Corporation of the
Village of Cumberland

*Heritage
Committee*

TO: Heritage Committee members
FROM: Karin Albert, Senior Planner
SUBJECT: Heritage Alteration Permit and Variance Applications – 2714 Dunsmuir Avenue

- i. THAT the Heritage Committee receive the “Heritage Alteration Permit and Variance Application – 2714 Dunsmuir Avenue (2021-02-HAP)” report.
- ii. THAT the Heritage Committee recommend to Council to request that the applicant revise the design of the proposed building at 2714 Dunsmuir Avenue (2021-02-HAP) to meet the Village’s Heritage Conservation Area guidelines:

SITE PLAN - OVERALL

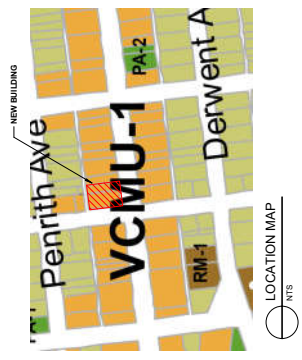
- b. Show a 1.5 metre setback to the lane that is free of any structures.
 - c. Provide a landscape plan (close-up view and plant list) for the planters proposed.

Both sheltered bicycle parking for business owners or employees and public bicycle parking are provided. The architect is asked to show the 1.5 m Statutory Right-of-Way to the lane on the plan. This may affect some of the public bicycle parking and will be reviewed prior to finalizing the Heritage Alteration Permit.

Site plan showing a 1.5 m setback to be attached

SOUTH ELEVATION STREETSCAPE

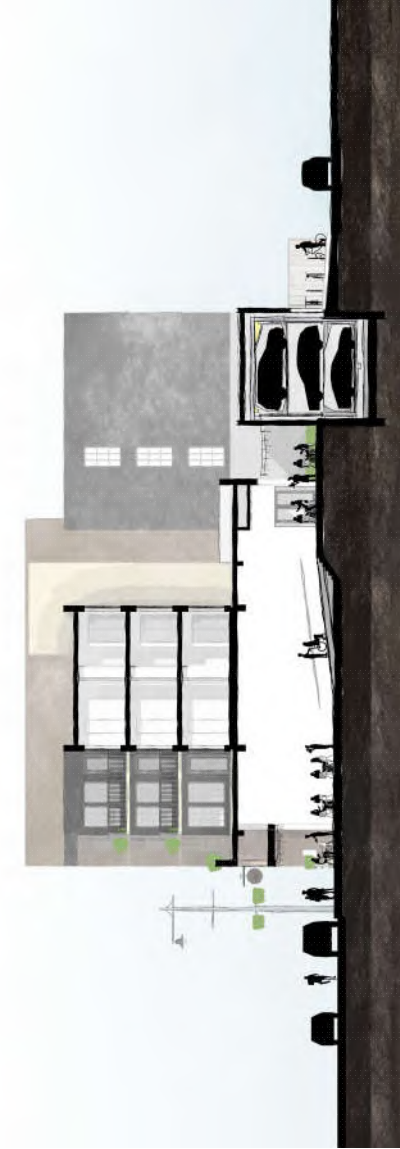
Overall, the building meets the form and character design guidelines. However, the drawings provided make it difficult to interpret materials and colours and how the building fits within the streetscape. Staff recommends that the applicant be asked to provide photographic renderings showing building materials and colours and views from all four sides.

The renderings may be able to address public concerns regarding the prominence of the southwest corner and, generally, how the building fits into the streetscape (see attachments to the Council Report for public comments). The Committee may provide further suggestions to the architect. Attachment 2, a photo record showing some of the existing buildings on Dunsmuir Avenue, is provided to assist with that discussion.
